**Civil Nuclear Reactor Programme**

**Safety categorisation and classification workstream assessment to inform nuclear  
site licensing of Hinkley Point C**

Assessment Report: ONR-CNRP-AR-12-081

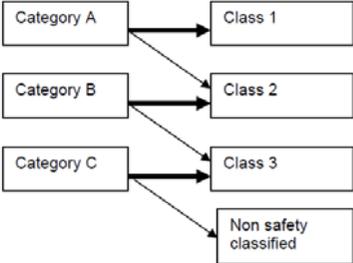
Batch/Comment	Comment	NNB GenCo response	Status for licensing <sup>3</sup>
<b>Batch 5</b>			
1	<p>Whereas a new safety classification system is being developed, in order to address a GDA issue, and the report states that a new version of the report will be provided at PCSR3, prior to construction, that will incorporate this, the overall basis of the classification is not clear. For example, a number of the systems are claimed to be not safety classified, or have a low safety classification, but there is no discussion on the basis of these claims.</p> <p>Furthermore, it is not clear whether the new classification approach will change any of the conclusions in this report or the</p>	<p>The UK-EPR Safety Classification methodology for SSCs is based on three steps:</p> <ul style="list-style-type: none"> <li>• Identification of the Safety Functions, and categorisation of said safety functions based on the relative significance to nuclear safety (Cat A, B or C). In this context, "significance to nuclear safety" means the importance to delivering one or more of the 3 fundamental safety functions (criticality; cooling; containment).</li> <li>• Identification of the systems (or groups of systems) which deliver these functions, and classifying them, based on their importance to delivering the function. (Class 1, 2 or 3). See figure below:</li> <li>• The final step is to apply the classification to the system, and break it down into the component parts, such that individual components are classified. Note, if a system is class 1, not all of the components may be important to delivering the class 1 requirements of the system. Some components may play no role at all and failure would not impair the system. Therefore, they may be classified at a lower class (see diagram below).</li> </ul>	<p>CLOSED – NNB GenCo's response when taken with sampling the derisking activities is considered adequate for licensing.</p>

Batch/Comment	Comment	NNB GenCo response	Status for licensing <sup>3</sup>
	<p>design of the heat sink. I don't believe this to be a major issue, but NNB GenCo should make the implications of this change clear.</p>	<p>The figure below presents a simplified illustration of the relationship between categories and classes.</p>  <pre> graph LR     A[Category A] --&gt; C1[Class 1]     B[Category B] --&gt; C2[Class 2]     C[Category C] --&gt; C3[Class 3]     C --&gt; NSC[Non safety classified]         </pre> <p>GDA will not provide a complete list of categorised functions or classified systems. The main safety systems on the nuclear island (i.e. those covered in GDA) will be classified, but a lot of the site-specific SSCs will not be.</p> <p>The AE have developed a process to implement the classification methodology to HPC. This process is governed by CNEN/SNE and the AE/NNB Classification Working group.</p> <p>The aim is to deliver a complete list of categorised functions and classified systems by the end of 2013.</p> <p>In the interim, we will need to review and place contracts (or review design deliverables) for SSCs which will not be formally classified in the UK-EPR context. For these situations, a separate workstream of "de-risking" is being carried out. This de-risking activity is not to decide the final classification of the SSCs, it is to identify the highest classification that the SSC could have. This ensures that the FA3 classification is not simply assumed and also that a</p>

Batch/Comment	Comment	NNB GenCo response	Status for licensing <sup>3</sup>
		supplier is not selected who (if the class is upgraded) does not have the capability to design to such a standard. The de-risking activities must be completed before signing of contract.
